Access Compliance Report

Public Rights-of-Way

(Curb Ramps)

Intersection ID: 49506	Main Street: OSCEOLA_LN	Cross Street: WATERLOO_DR	Location: S
ADA ID: B4FCD585CC2D	Ramp Type: PerpDiag	Initial Pass/Fail: Fail	Overall Compliance: No
Severity Score: 22.5			
Codes/Mitigation Info/Possible Solution		Field Measurements/Component Compliance

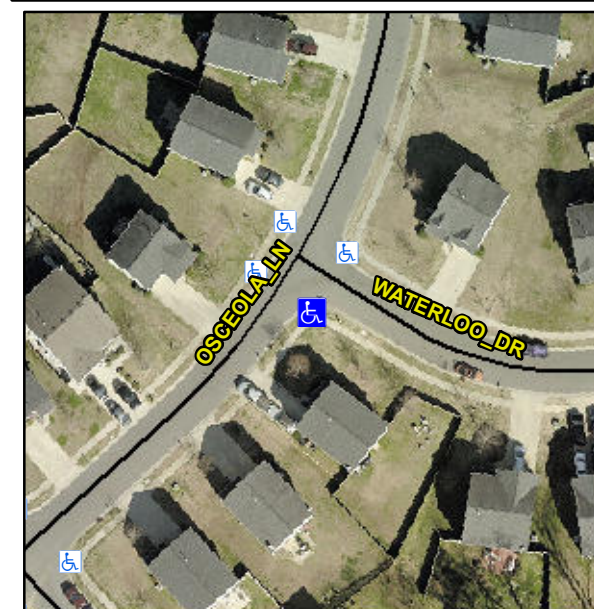
Not Found, R304.5.1, R304.2.2, R304.5.3

Compliance	Description	Data	Compliance	Description	Data
N/A	Ramp Length (in)	46.0	No	Ramp Slope (%)	9.2
No	Ramp Width (in)	47.5	No	Ramp XSlope (%)	3.8
N/A	Flare Type LT	N/A	N/A	Flare Type RT	N/A
N/A	Flare Slope LT (%)	N/A	N/A	Flare Slope RT (%)	N/A
N/A	Flare Traversable LT?	N/A	N/A	Flare Traversable RT?	N/A
N/A	Landing Length (in)	N/A	N/A	DWS Provided?	N/A
N/A	Landing Width (in)	N/A	N/A	DWS Contrast?	N/A
N/A	Landing Slope (%)	N/A	N/A	DWS Length (in)	N/A
N/A	Landing X Slope (%)	N/A	N/A	DWS Full Width?	N/A
N/A	Landing Curb? (Y/N)	N/A	N/A	DWS Offset (in)	N/A
N/A	Shared Landing?	N/A			
N/A	Gutter Ponding?	N/A	N/A	Gutter Slope (%)	N/A
N/A	Gutter Lip Ht (in)	N/A	N/A	Gutter X Slope (%)	N/A
N/A	Painted X Walk1?	No	N/A	Painted X Walk2?	No
	X Walk 1 Direction	To NE		X Walk 2 Direction	To NW
N/A	X Walk 1 Width (in)	N/A	N/A	X Walk 2 Width (in)	N/A
	X Walk 1 Slope (%)	0.7		X Walk 2 Slope (%)	4.6
	X Walk 1 X Slope (%)	3.6		X Walk 2 X Slope (%)	0.7

Remove & Replace Curb Ramp With Two New Directional Ramps or Equivalent.
